GS# 106-281 Demolition - Residence Hall

Mississippi Valley State University, Itta Bena, MS

August 29, 2025

Addendum No. 2

C110
EROSION AND
SEDIMENT
CONTROL PLAN

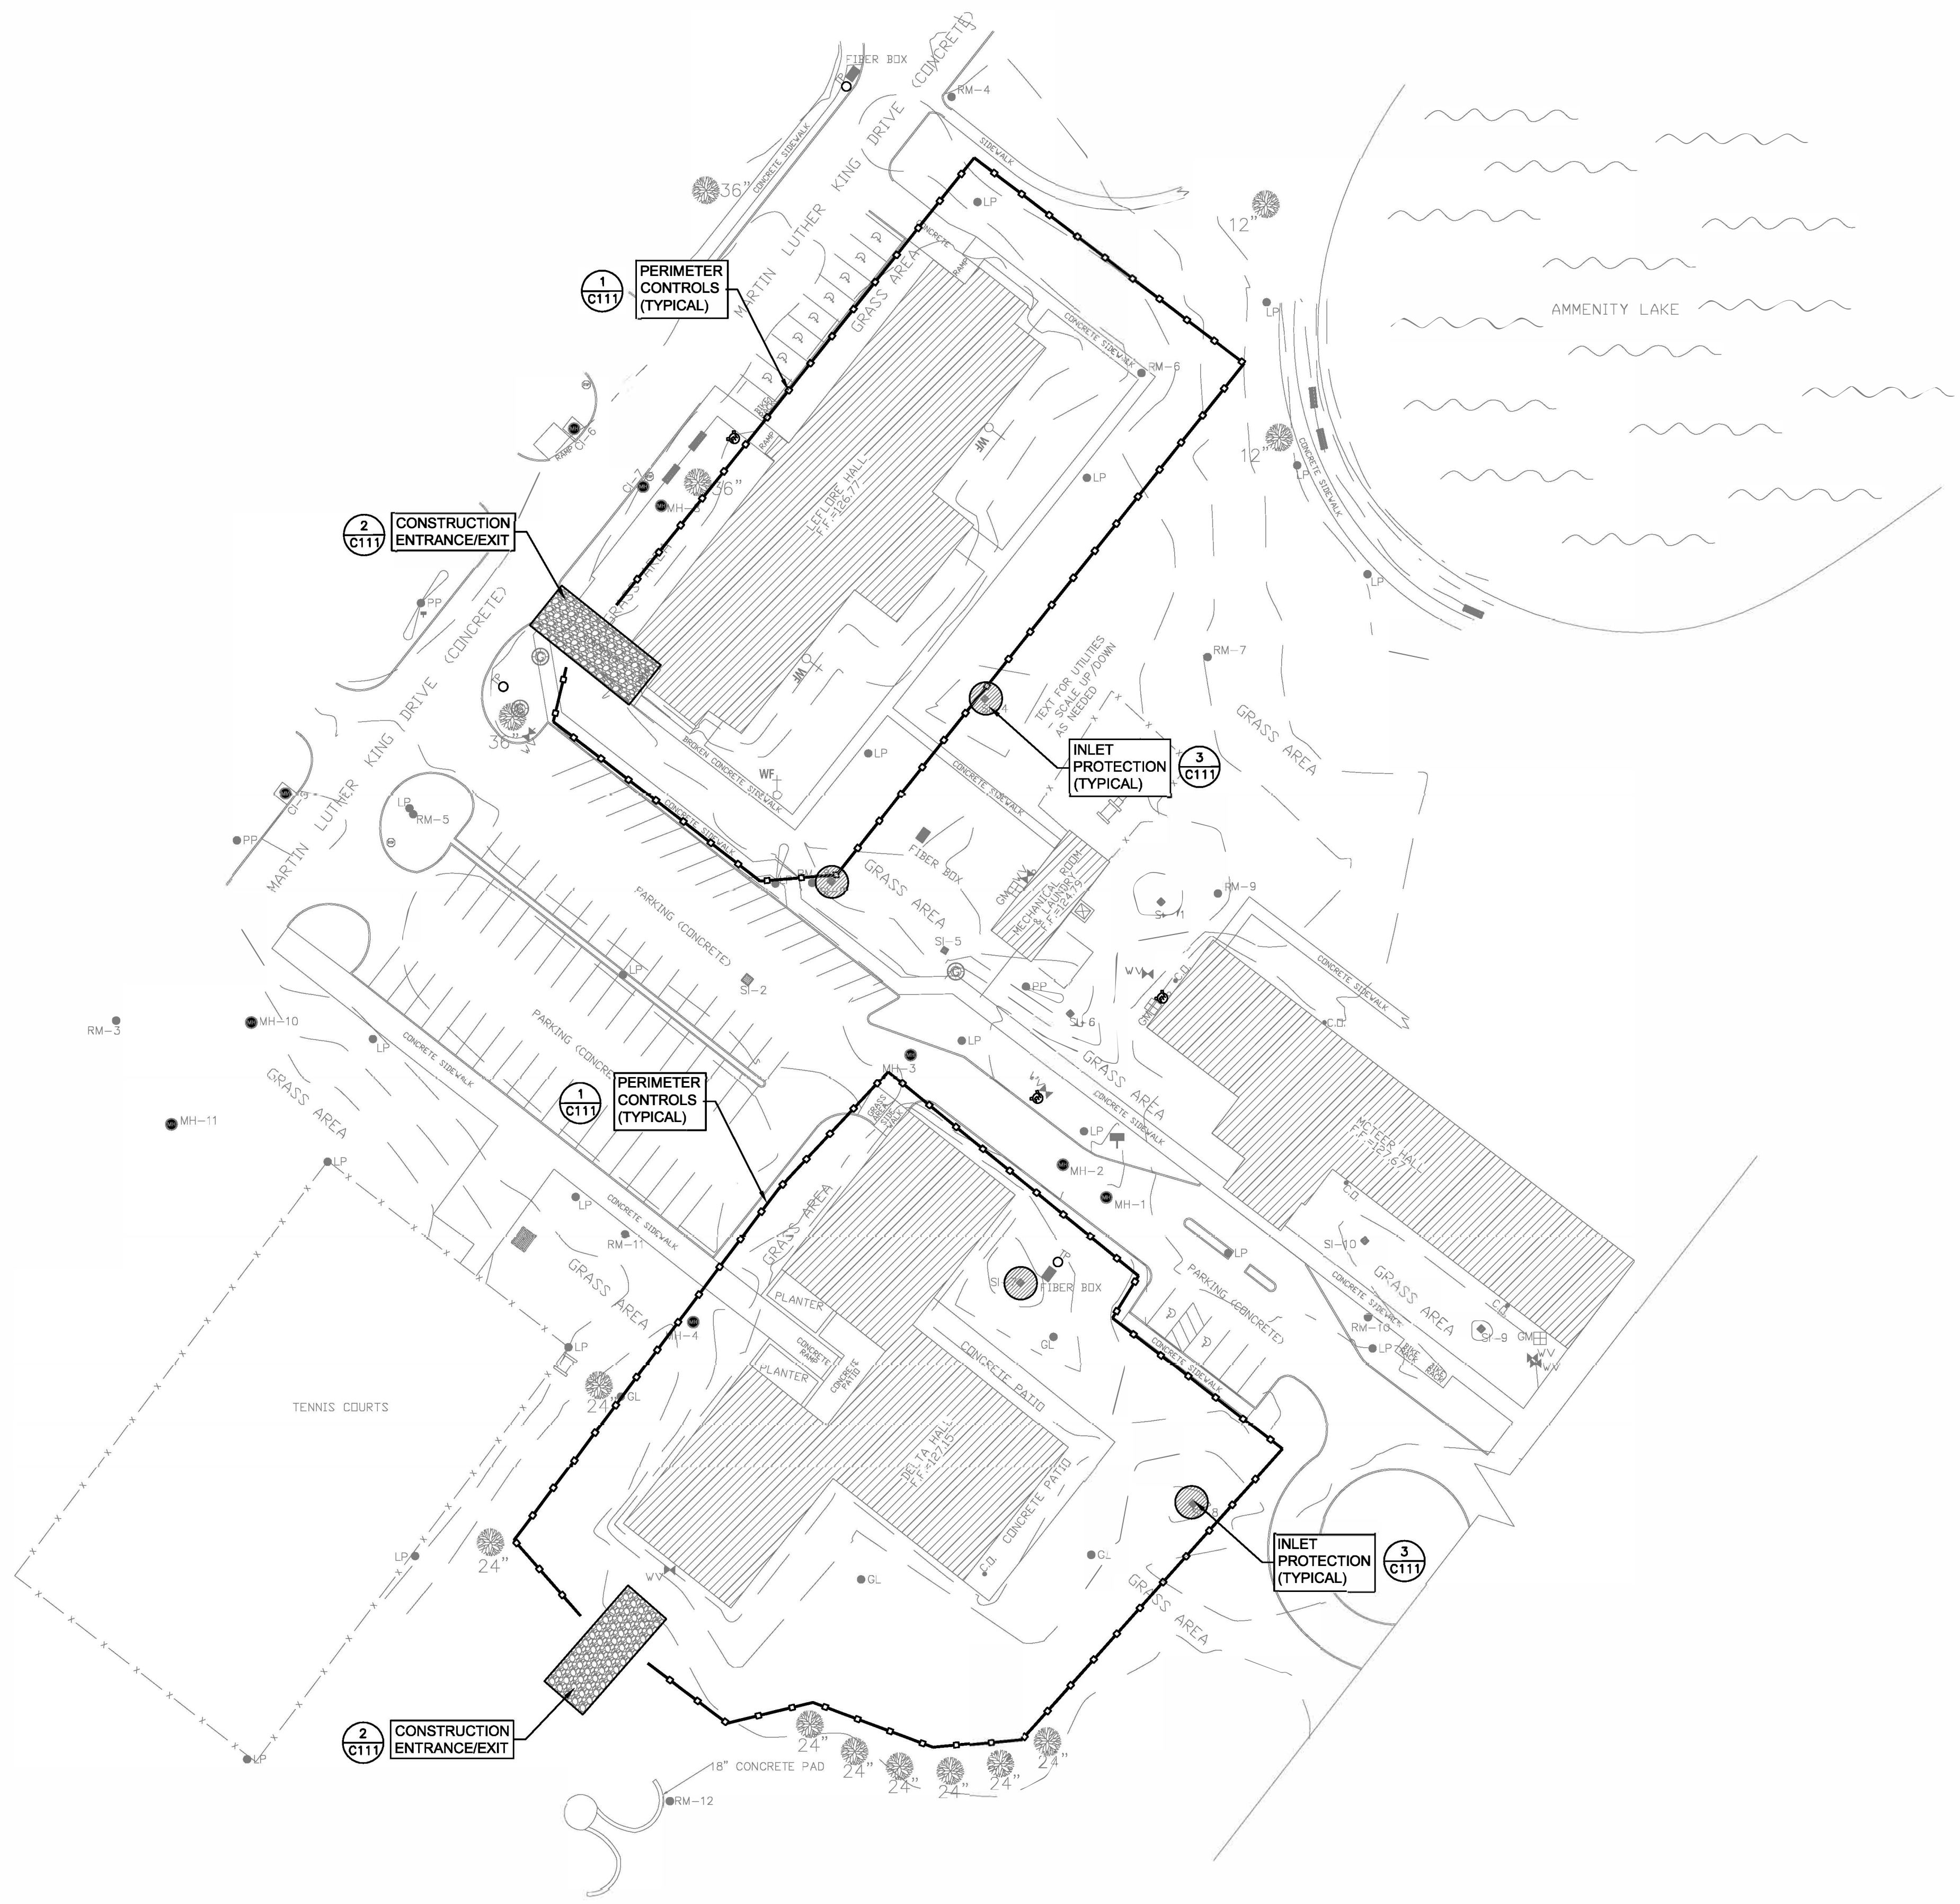
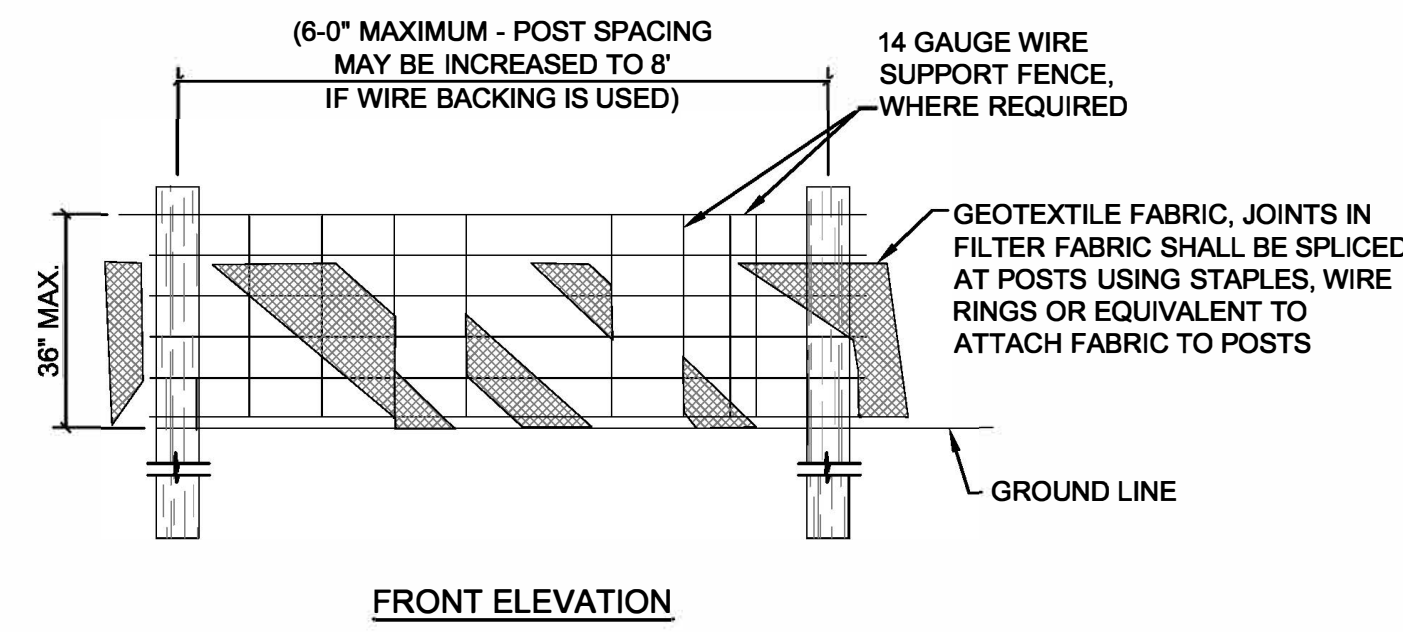
8. See drawing sheet C110. This drawing shows the approximate location of job site fencing and site access. Also see pages 6 and 7 of the attached "Project Scope Of Work And Utility Demolition/Protection Notes". Note that the proposed access points to the site(s) are identified on this drawing. However, the actual access points will be allowed to be adjusted as necessary for the actual means and methods that the successful contractor intends to use. In general, the access will be from the south-west of the site. The contractor will use Dr. Martin Luther King Jr. Drive to access Sunflower Road to the south-west. There is a gate at the south-west end of Dr. Martin Luther King Jr. Drive that the contractor will be allowed to use. However, this gate must remain locked at all times that the contractor is not using it for access. If the gate is being used continuously by the contractor (and the gate is not locked), the contractor must have a man stationed at the gate to restrict public use of this gate.

- a. The contractor will be responsible for documenting the condition of both Dr. Martin Luther King Jr Drive and Sunflower Road prior to the beginning of the work. This documentation shall be by means of video and photographs to show the existing conditions of these roads. These roads will then be evaluated once the work is complete. The repairs of any damage to these roads that is determined to have been caused by construction activities will be the responsibility of the contractor. The contractor will be responsible for roadway and parking lot protection that is necessary to preserve these surfaces from all construction activities.
